# Access Compliance Report

## Public Rights-of-Way

Intersection ID: 27889	Main Street: ELROSE_PL	Cross Street: GANDER_DR	Location: W
ADA ID: AAA8E602C5C7	Ramp Type: PerpDiag	Initial Pass/Fail: Fail	Overall Compliance: No
			Severity Score: 21.25

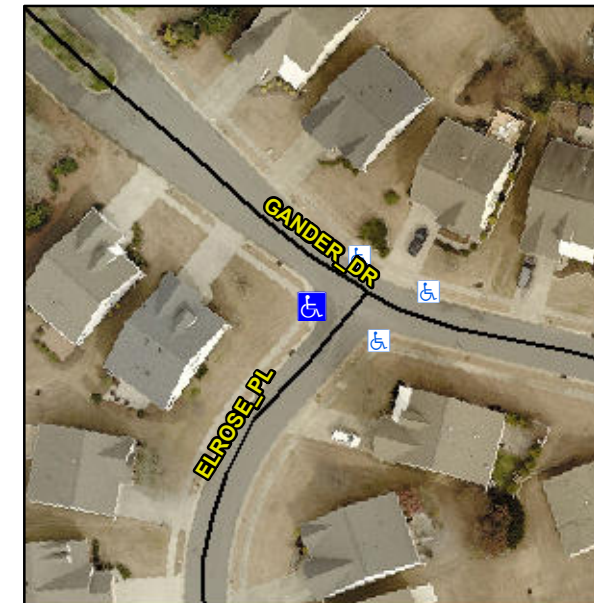
**Not Found, R304.5.1, R304.5.3**

Compliance	Description	Data	Compliance	Description	Data
N/A	Ramp Length (in)	96.0	Yes	Ramp Slope (%)	7.3
No	Ramp Width (in)	44.5	No	Ramp XSlope (%)	6.5
N/A	Flare Type LT	N/A	N/A	Flare Type RT	N/A
N/A	Flare Slope LT (%)	N/A	N/A	Flare Slope RT (%)	N/A
N/A	Flare Traversable LT?	N/A	N/A	Flare Traversable RT?	N/A
N/A	Landing Length (in)	N/A	N/A	DWS Provided?	N/A
N/A	Landing Width (in)	N/A	N/A	DWS Contrast?	N/A
N/A	Landing Slope (%)	N/A	N/A	DWS Length (in)	N/A
N/A	Landing X Slope (%)	N/A	N/A	DWS Full Width?	N/A
N/A	Landing Curb? (Y/N)	N/A	N/A	DWS Offset (in)	N/A
N/A	Shared Landing?	N/A			
N/A	Gutter Ponding?	N/A	N/A	Gutter Slope (%)	N/A
N/A	Gutter Lip Ht (in)	N/A	N/A	Gutter X Slope (%)	N/A
N/A	Painted X Walk1?	No	N/A	Painted X Walk2?	No
	X Walk 1 Direction	To SE		X Walk 2 Direction	To NE
N/A	X Walk 1 Width (in)	N/A	N/A	X Walk 2 Width (in)	N/A
	X Walk 1 Slope (%)	1.2		X Walk 2 Slope (%)	3.9
	X Walk 1 X Slope (%)	1.9		X Walk 2 X Slope (%)	3.7

**Remove & Replace Curb Ramp With Two New Directional Ramps or Equivalent.**
